SERVICE BULLETIN

NO: 11092301

Models: TX-NR708; TX-NR709; TX-NR808; TX-NR1008; TX-NR3008; TX-NR5008; DTR-40.2; DTR-50.2; DTR-70.2; DTR-80.2; DHC-40.2; DHC-80.2; HT-RC270; PRSC5508; HT-RC370

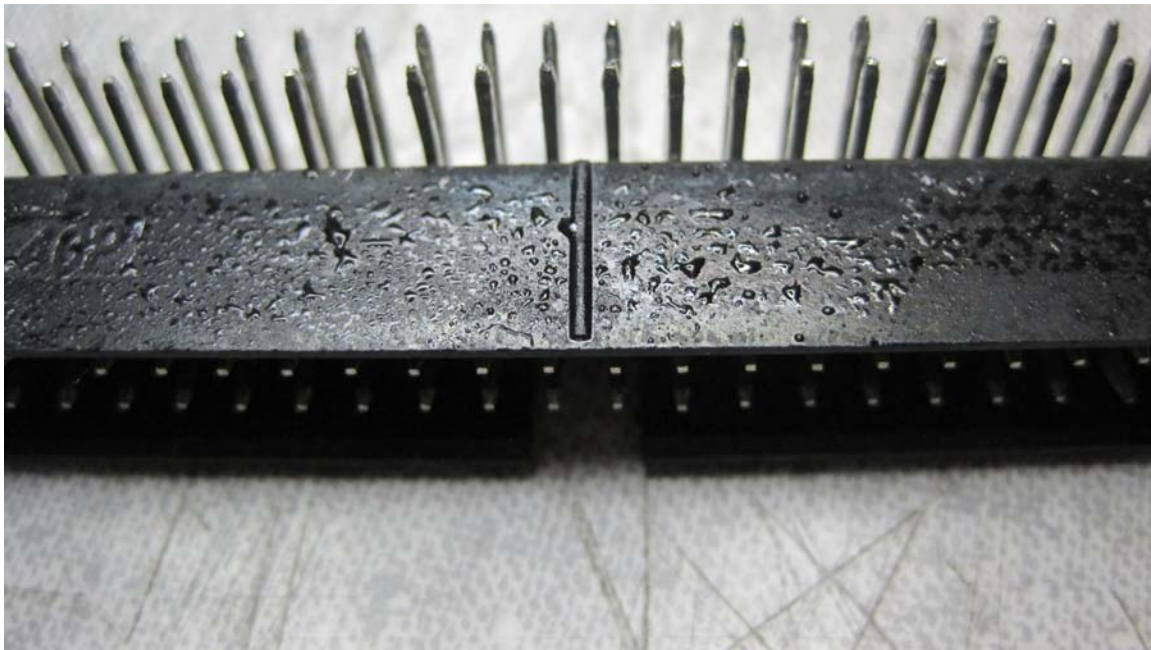
Important Note #2: After taking out both connectors clean the surface of the PCB before mounting the new connectors. Please see picture below. It shows the bottom surface of the bad connector. As you can see there is a lot of residue, which contaminates the board surface. It is must that you clean the surface on the PCB before mounting the connector.

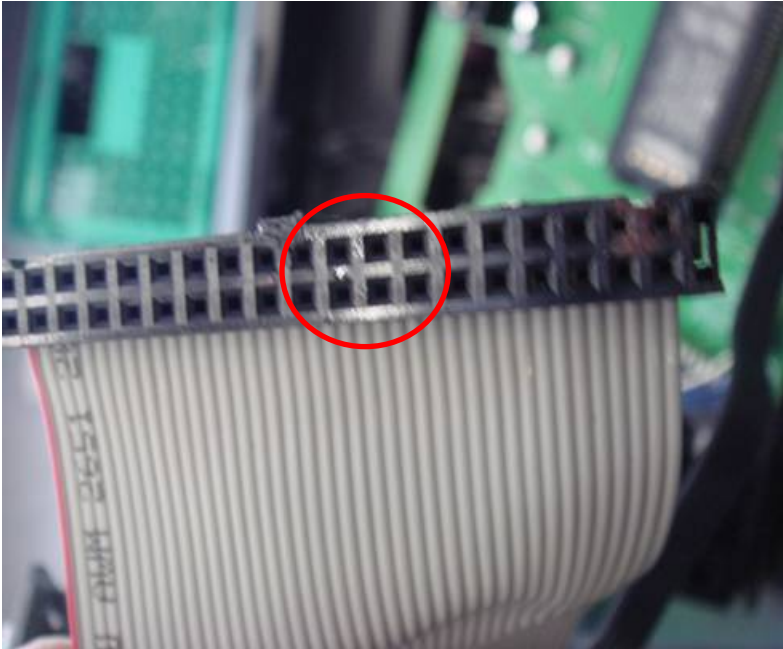
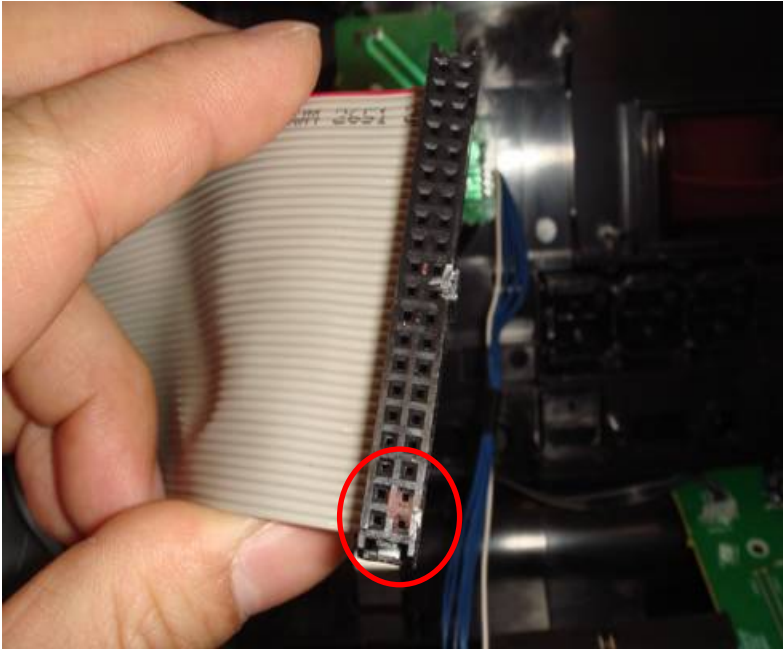
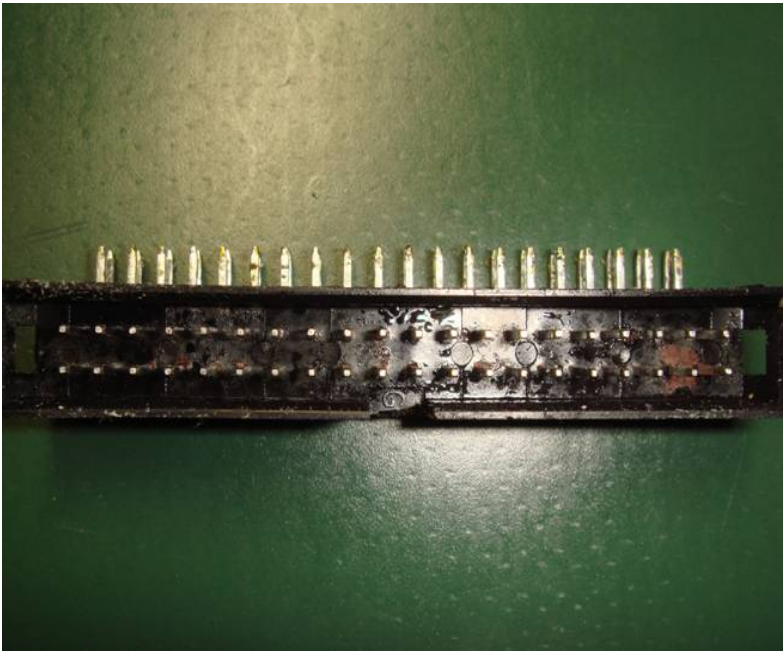
Cause: Insulation failure between pins of IDE connector(s) might cause erratic behavior of Microprocessor. Contact problem in IDE cable from display board to micro board.

For all of these units, replace both connectors (plugs) P7501A/B and the IDE cable. P7501A is on Main CPU Board, and P7501B is on Display Board.
